Access Compliance Report

Public Rights-of-Way

(Curb Ramps)

Intersection ID: 24782	Main Street: BLACK_DUCK_CT	Cross Street: CANVASBACK_DR	Location: S
ADA ID: FBB5A66B8340	Ramp Type: PerpDiag	Initial Pass/Fail: Fail	Overall Compliance: No
Codes/Mitigation Info/Possible Solution		Field Measurements/Component Compliance

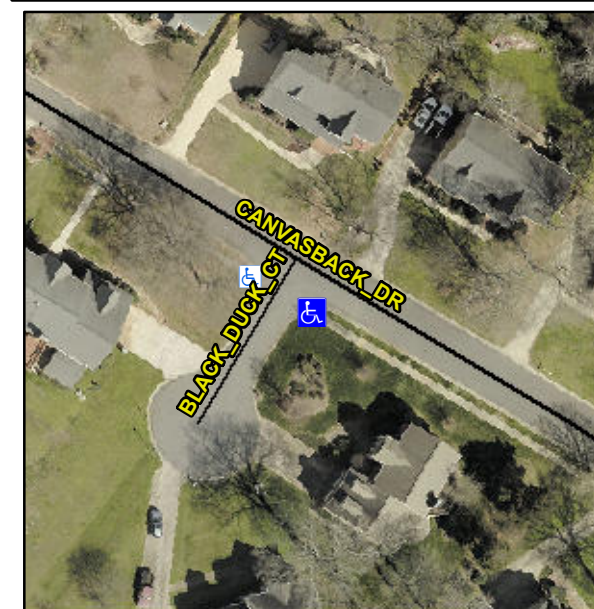
Not Found, R304.5.1, R304.5.3

Compliance	Description	Data	Compliance	Description	Data
N/A	Ramp Length (in)	40.0	Yes	Ramp Slope (%)	6.5
No	Ramp Width (in)	47.5	No	Ramp XSlope (%)	5.2
N/A	Flare Type LT	N/A	N/A	Flare Type RT	N/A
N/A	Flare Slope LT (%)	N/A	N/A	Flare Slope RT (%)	N/A
N/A	Flare Traversable LT?	N/A	N/A	Flare Traversable RT?	N/A
N/A	Landing Length (in)	N/A	N/A	DWS Provided?	N/A
N/A	Landing Width (in)	N/A	N/A	DWS Contrast?	N/A
N/A	Landing Slope (%)	N/A	N/A	DWS Length (in)	N/A
N/A	Landing X Slope (%)	N/A	N/A	DWS Full Width?	N/A
N/A	Landing Curb? (Y/N)	N/A	N/A	DWS Offset (in)	N/A
N/A	Shared Landing?	N/A			
N/A	Gutter Ponding?	N/A	N/A	Gutter Slope (%)	N/A
N/A	Gutter Lip Ht (in)	N/A	N/A	Gutter X Slope (%)	N/A
N/A	Painted X Walk1?	No	N/A	Painted X Walk2?	No
	X Walk 1 Direction	To NE		X Walk 2 Direction	To NW
N/A	X Walk 1 Width (in)	N/A	N/A	X Walk 2 Width (in)	N/A
	X Walk 1 Slope (%)	7.5		X Walk 2 Slope (%)	3.9
	X Walk 1 X Slope (%)	1.1		X Walk 2 X Slope (%)	5.7

Remove & Replace Curb Ramp With Two New Directional Ramps or Equivalent.
